SUBJECT: TO ADVISE M20TN OWNERS OF CORRECT PART NUMBERS AND MOUNTING SEQUENCE OF THE ENGINE MOUNT ISOLATORS AND RELATED HARDWARE AS SHOWN IN BOTH THE SERVICE MANUAL AND ILLUSTRATED PARTS CATALOG.

MODELS/ SN AFFECTED: Mooney M20TN 31-0001 THRU 31-0023 and 31-0025 THRU 31-0127

INTRODUCTION: There is incorrect Engine Mount Isolator data identified within the M20TN Service Manual (part number MAN180) and M20TN Illustrated Parts Catalog (part number MAN280). Both the Service Manual and Illustrated parts Catalog will be updated at their next revision cycle to reflect this information. This Service Instruction also contains tips on how to install new mounts as done at the factory.

SERVICE INSTRUCTION M20-121

Figure 1 - ENGINE MOUNT AND HARDWARE INSTALLATION

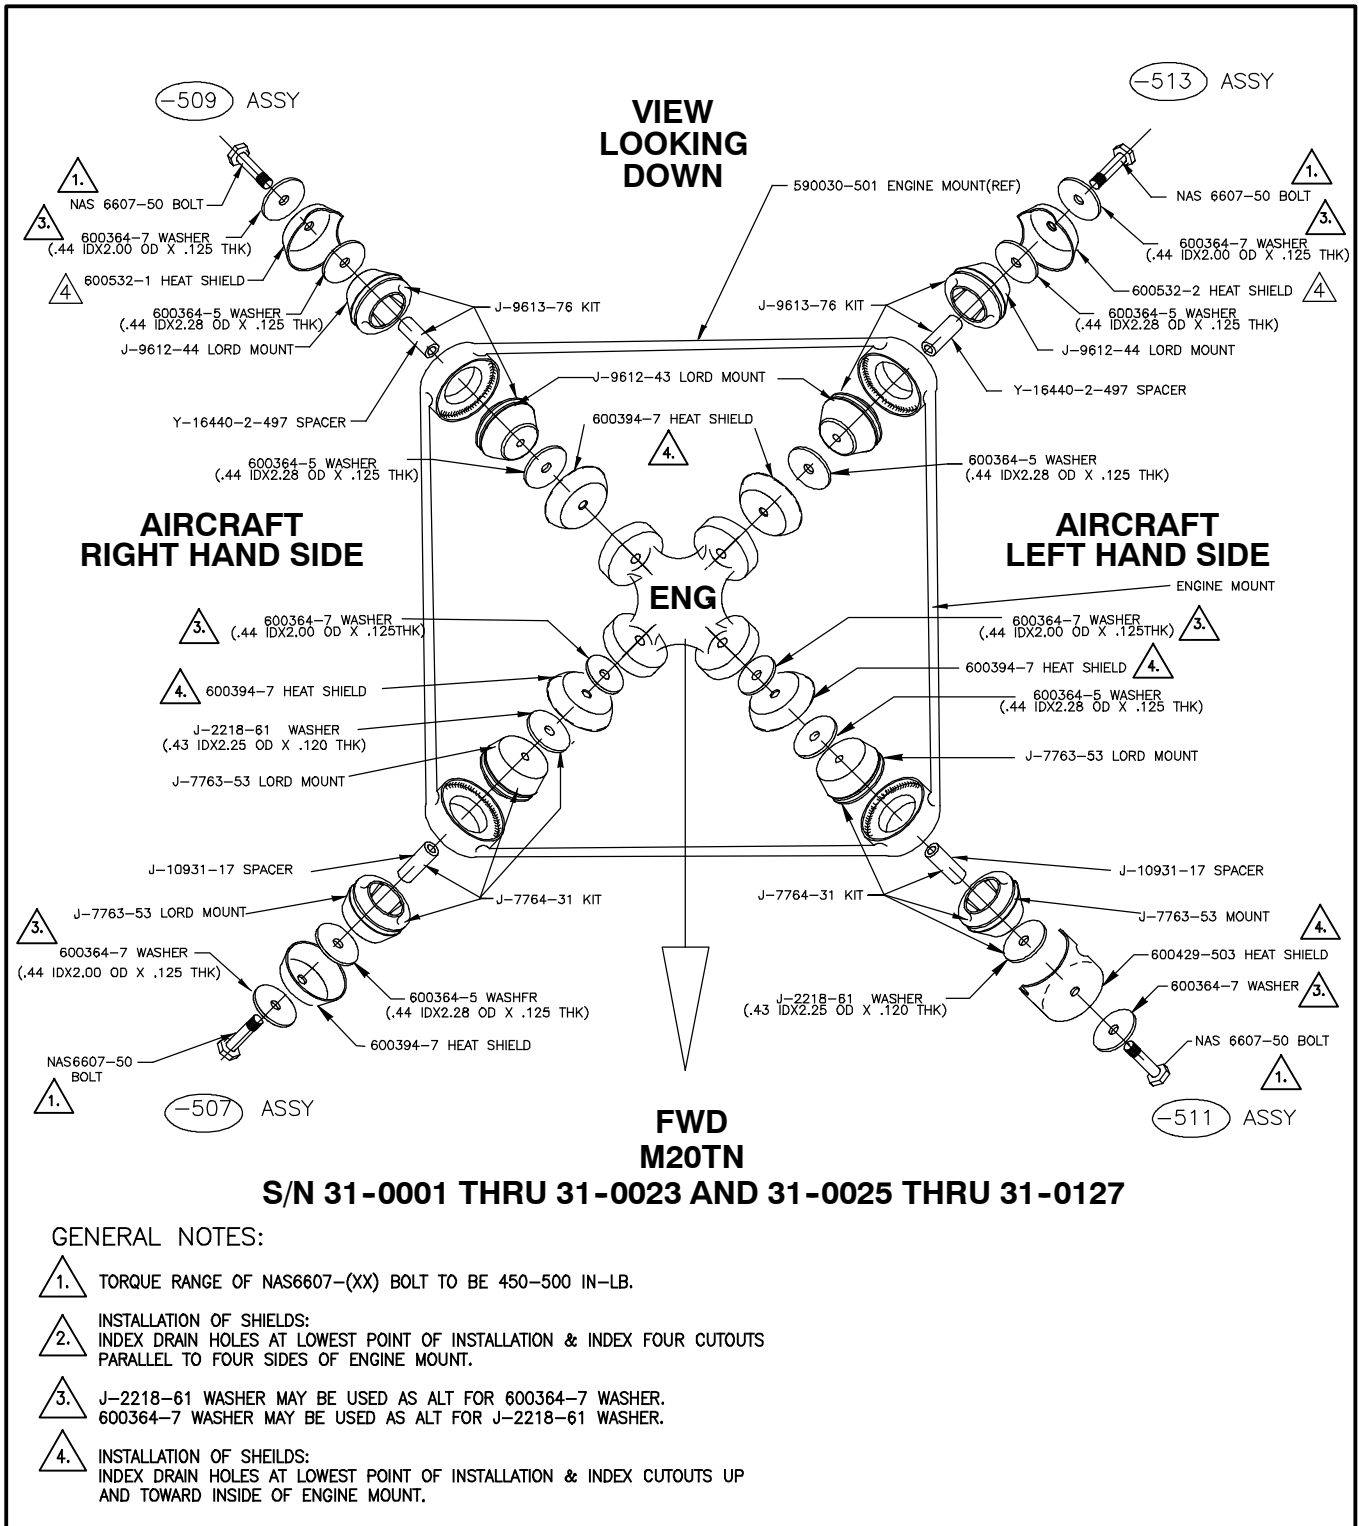
The arrangement of engine isolator mounts is extremely critical. Make certain they are arranged as shown in Figure 1.

- 1.13. Correctly position each heat shield in place per figure 1, index drain holes at lowest point of installation & index cutouts parallel to sides of engine mount. Make sure heat shields are oriented to prevent chaffing or interference on engine mount or engine components.
- 1.14. Install both retaining bolts, washers and torque to specification - refer to Figure 1.

Figure 2 - INSTALL ENGINE ISOLATOR MOUNTS AND HARDWARE

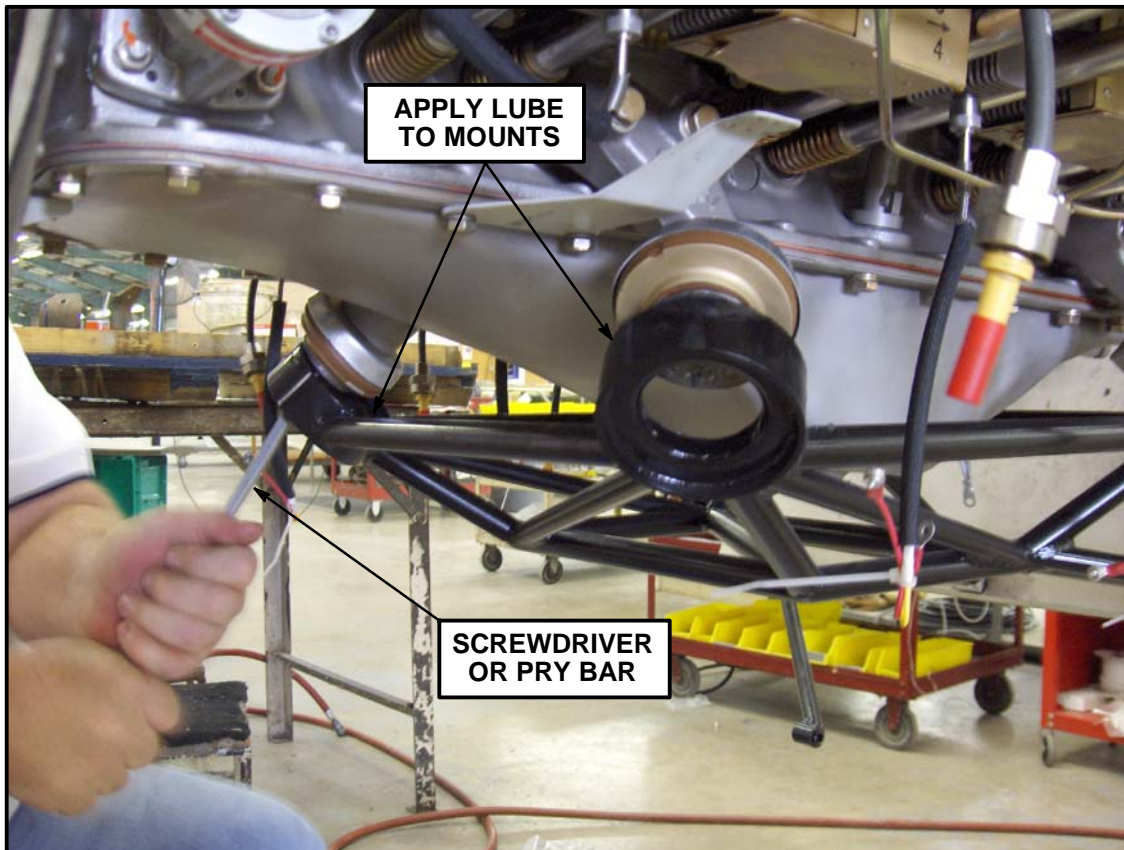
- 1.8. Use "dummy" bolts (NAS6607-15 or equivalent) and washers to secure each of the top halves of isolator mounts with upper washer and heat shields in place to engine motor mount castings (4 places). Tighten bolts to compress rubber mounts to approximate thickness shown in Figure 2.
- 1.9. Before lowering engine, lube all four mount cups with silicone lubricant to help facilitate alignment.
- 1.10. Slowly lower engine into motor mount cradle. Support weight of engine with lift until engine is properly placed in mount. When engine is first lowered, the isolator mounts will not rest squarely in the cups on the mount refer to Figure 2. Seat both rear mounts first, then front left & right mounts.
- 1.11. Use a large flat screwdriver to pry mounts into cups. This step requires a considerable amount of patience and "elbow grease" - refer to Figure 2.

TIGHTEN "DUMMY" BOLTS (NAS6607-15 OR EQUIVALENT) TO COMPRESS RUBBER MOUNTS

ISOLATOR MOUNT SEATED
REMOVE - "DUMMY" BOLTS
